Access Compliance Report Public Rights-of-Way (Pedestrian Signals)

Main Street: CROWN_VALLEY_PKWY Cross Street: ANTONIO_PKWY Location: SW

ADA ID: SGRK211022135823 Signal Type: One Push Button-Non APS Overall Compliance: No Severity Scores: BTN 1: 35 BTN 2: N/A No BTN: N/A

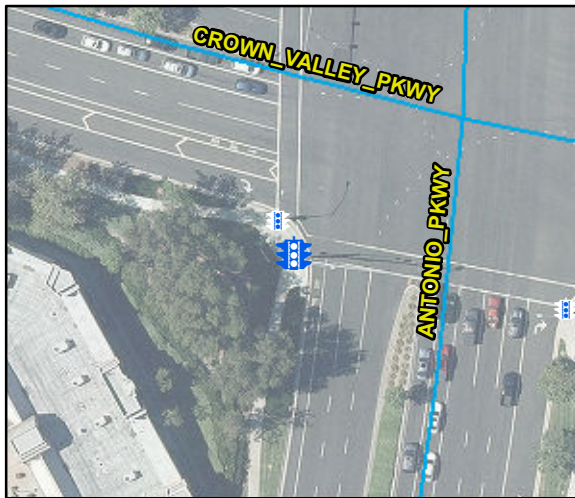
Surveyor Notes: Clear Space in Ramp

OC Std/PROW: R404.2, MUTCD 4e.08

Possible Solutions: Replace Signal Push Button With APS Button. Remove and Replace Clear Space.
